Reference Number	Bulletin 02 – 2018
Affected Product	All Terex/Unit Rig MT3700 & MT4400 trucks with 1"-14TPI front wheel studs
Risks Identified	Potential separation of front tyre and rim from wheel hub, or rim rotation on hub.
Release Date	November 20 2018

MT3700 & MT4400 front wheel fasteners: potential for insufficient rim clamping

Figure 2 - UNACCEPTABLE stud and clamp combination, the stud thread ends above the nut seating surface of the clamp.

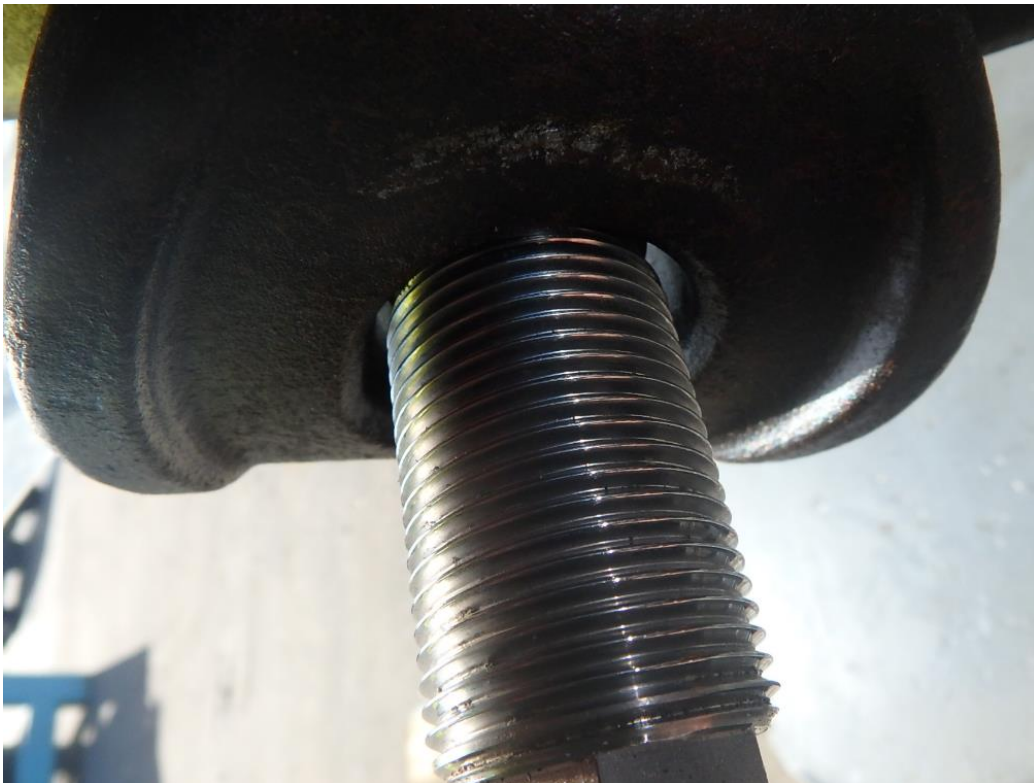
As a guide, if there is 10mm or more of stud thread projection above the nut, the clamp and the stud should be inspected to ensure the nut can NOT bottom-out at the end of the threaded section of the stud before the clamp can be effective.

If the nut can bottom-out, the defective stud, nut or clamp must be replaced. It is good practice to replace all components at an individual wheel position with new components as a set.
